CERTIFICATE OF APPROPRIATENESS

Property: Tract 2, Block 276, Houston Heights Subdivision, City of Houston, Harris County, Texas. The site includes a 1-story 1,630 square foot residence situated on a 6,900 square foot (46'x150') lot. Approval for a two-story rear addition was granted at the February 2014 HAHC meeting.

Proposal: Alteration – Revision. The property received a COA for a rear two-story addition on February 13, 2014.

Recommendation: Approval of the proposed remediation plan

Project Comment Details

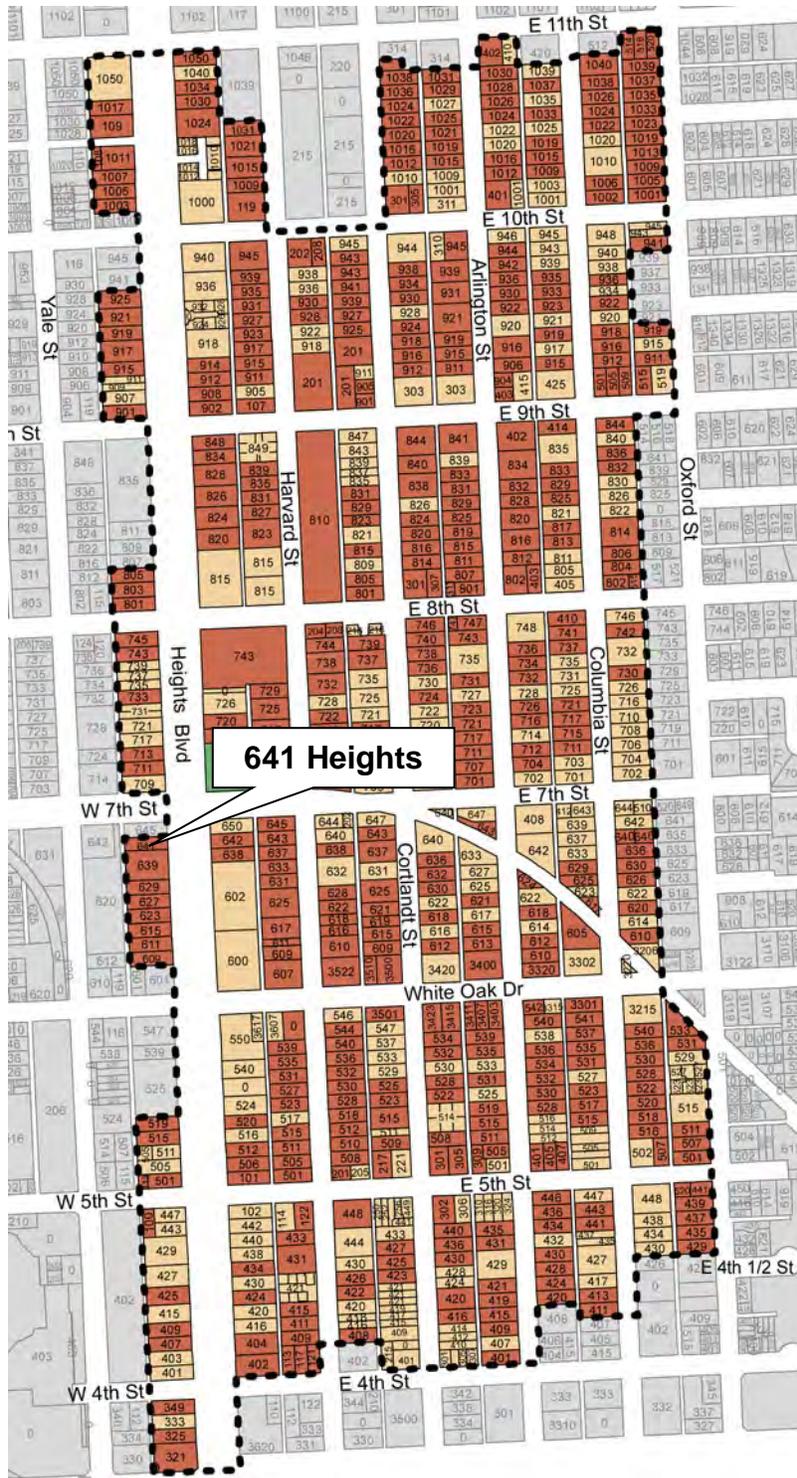
Comment: Stop Work per Margaret Brown in Planning

SOUTH ELEVATION

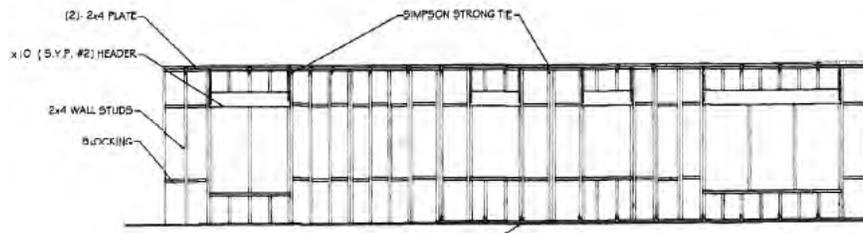
Exterior Materials: The original siding on the existing south elevation was removed without HAHC approval. The original trim was removed and replaced with textured cementitious material without HAHC approval. The original wood brackets were removed from the front elevation without HAHC approval.

Side Elevation: The existing southern wall will be resided with new wood 117 siding to match existing 117 siding.
(South) The original windows on this elevation will also be reinstalled into the original locations. All trim removed and replaced with textured cementitious trim will be replaced with wood trim to match original. See photos for more detail.

The existing southern wall will be resided with new wood 117 siding to match existing 117 siding. The existing cementitious trim will be removed and replaced with wood trim to match existing. The removed brackets will be replaced with new wood brackets. See photos for more detail.

INTERIOR REFRAMING PLAN
ANCHORAGE AND STRAPPING DETAIL

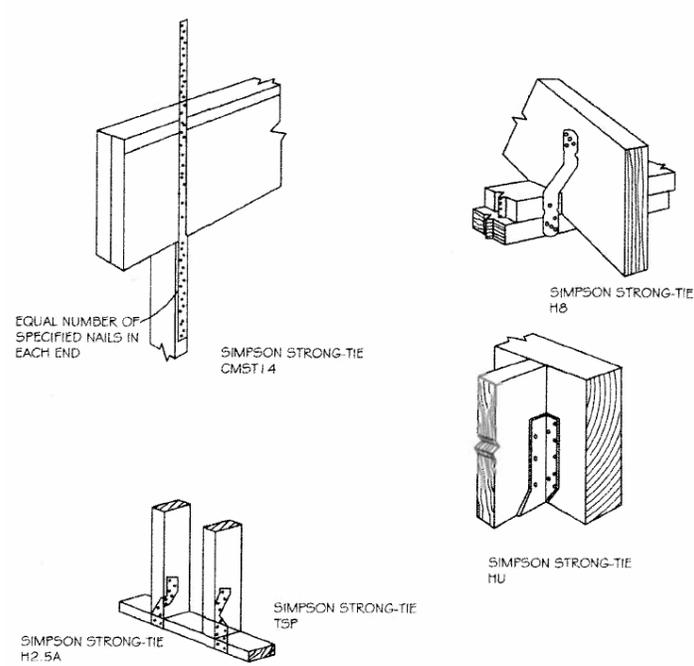
Windows: The original windows were removed in order to reframe the historic portion of the structure, which also involved the remove of the interior shiplap, all without HAHC approval.

The original windows have been retained and will be reinstalled into the original locations. See drawings for more detail.
